November 17, 2022

Re: Comments on EPA's Proposed Modification of the 2018 NPDES Permit for Schiller Station (Permit No. NH00014733)

**Figure 1: Schiller Daily Percentage Operation (Spring-Fall, April 2016-June 2020)<sup>11</sup>**

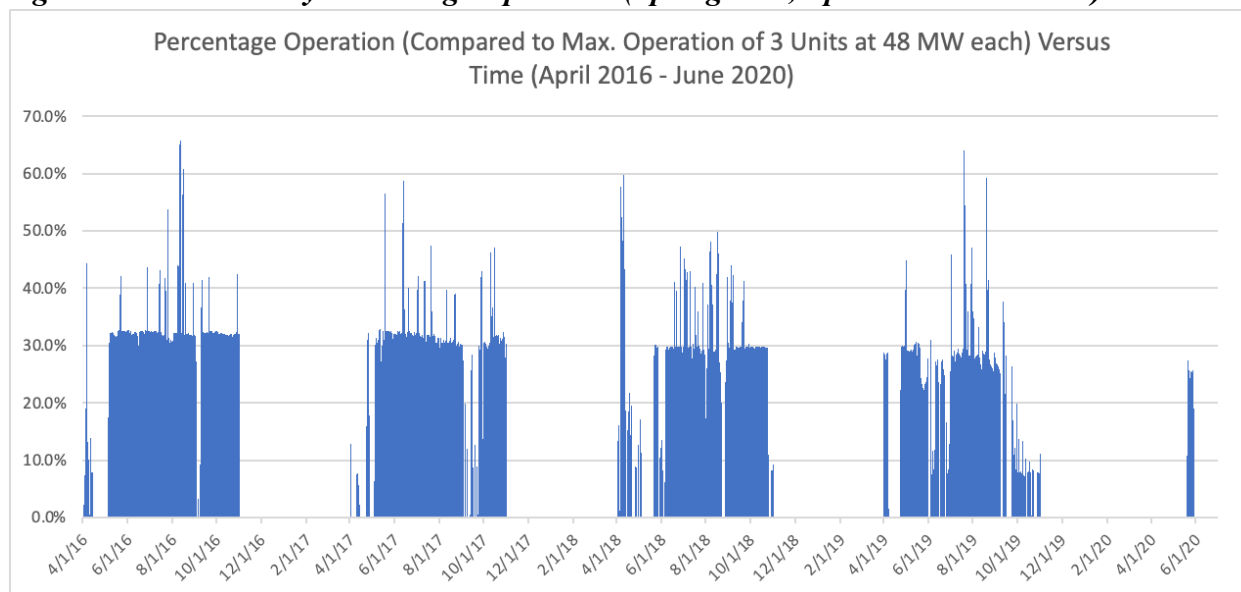
Indeed, daily operations above 33% capacity only amount to roughly 5% of overall days, meaning that the proposed 66% reduction in CWIS flows in the draft Modification would, at the very best, only reduce CWIS actual flows by 5% spread out over *five years*. Moreover, during the period examined there were hundreds of days involving much less than 33% capacity, meaning that EPA’s proposed CWIS flow limits would allow *increases* in flow levels—and concomitant entrainment—on those days.

**Figure 2: Weekly Mean Entrainment Density (2020 Normandeau Report)<sup>18</sup>**

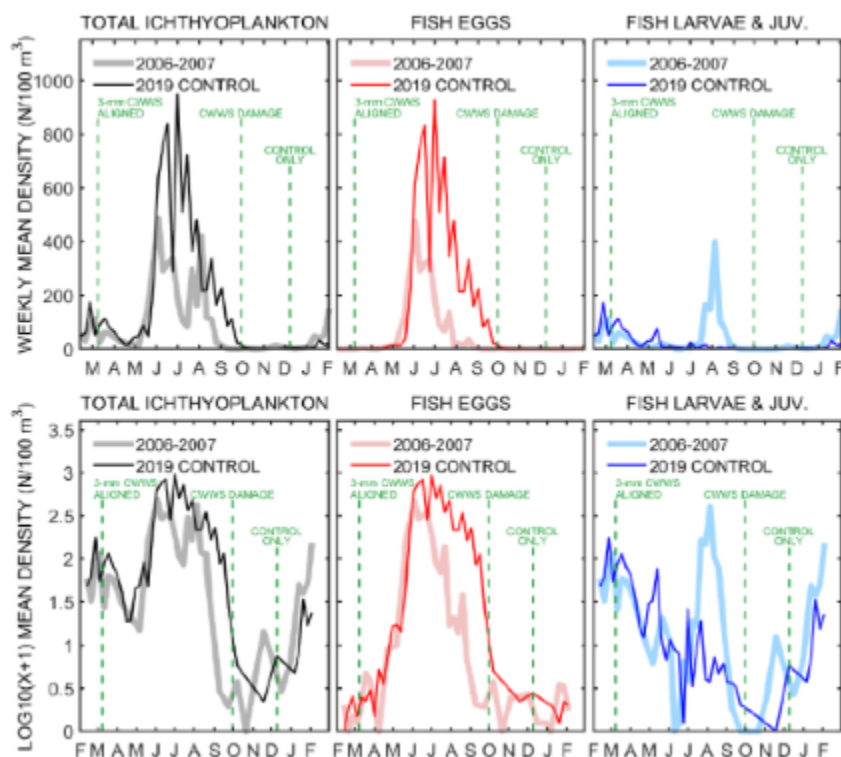
As an example of climate change and varying annual conditions shifting spawning timelines, Figure 11 of the 2020 Normandeau Report plots data from 2006-2007 as well as "2019 control" data. 2019 was a warmer year than 2006 and 2007, and there is a marked temporal shift in most of the plotted peaks in 2019 towards later months as compared to the earlier, cooler years.

Indeed, the 2020 Normandeau Report also does not support EPA’s proposed unconstrained CWIS flow limits and lack of BTA screens in December and January. As Figures 17 and 18 in that Report indicate, entrainment densities of eggs and larval and juvenile fish actually increased significantly in those months significantly with the preceding November and December. *See* 2020 Normandeau Report at 79-80. As such, reliance on seasonal CWIS flow limits to reduce harm commensurate with continuously-in-place screens is unsupported and inconsistent with the requirements of BTA.
